Access Compliance Report Public Rights-of-Way (Curb Ramps)

Main Street: NACIENTE_ST Cross Street: SENDERO_WAY Location: SW

ADA ID: RPRK211117125151 Ramp Type: Type 4 - Parallel Initial Pass/Fail: Fail Overall Compliance: No Severity Score: 16

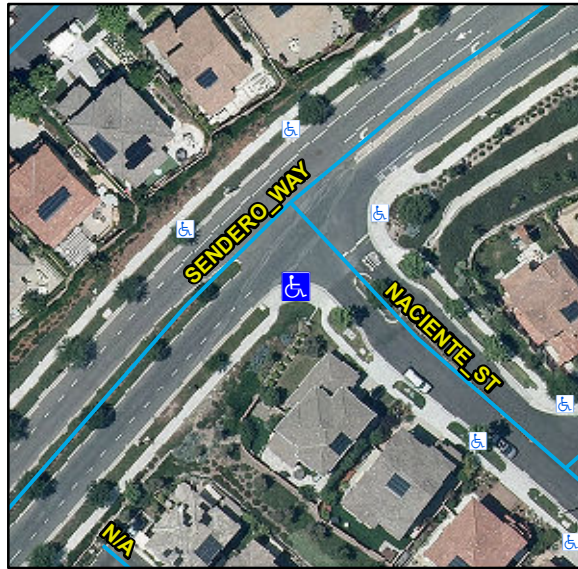
Compliance	Description	Data	Compliance	Description	Data
N/A	Ramp Length LT (in)	109	N/A	Ramp Length RT (in)	103
Yes	Ramp Width LT (in)	89	Yes	Ramp Width RT (in)	89
No	Ramp Run Slope LT (%)	8.8	No	Ramp Run Slope RT (%)	9
No	Ramp Cross Slope LT (%)	2.5	Yes	Ramp Cross Slope RT (%)	1.4
N/A	Landing Present	N/A	N/A	DWS Provided	N/A
N/A	Landing Length (in)	N/A	N/A	DWS Contrast	N/A
N/A	Landing Width (in)	N/A	N/A	DWS Length (in)	N/A
N/A	Landing Run Slope (%)	N/A	N/A	DWS Full Width	N/A
N/A	Landing Cross Slope (%)	N/A		DWS Offset Type	N/A
N/A	Landing Movement Obstructed?	N/A	N/A	DWS Offset Left (in)	N/A
	Landing Movement Type	N/A	N/A	DWS Offset Right (in)	N/A
N/A	Landing Shared	N/A			
N/A	Clear Space	Yes			
N/A	Clear Space To Crosswalk (in)	N/A			
N/A	Marked Crosswalk 1	No	N/A	Marked Crosswalk 2	No
	Crossing 1 Direction	E		Crossing 2 Direction	N
	Marked Crosswalk 1 Width (in)	N/A		Marked Crosswalk 2 Width (in)	N/A
N/A	Ramp Inside Crosswalk 1	N/A	N/A	Ramp Inside Crosswalk 2	N/A

Remove & Replace Curb Ramp With Two New Directional Ramps or Equivalent.

R304.3.2, R304.5.3, STD 1115
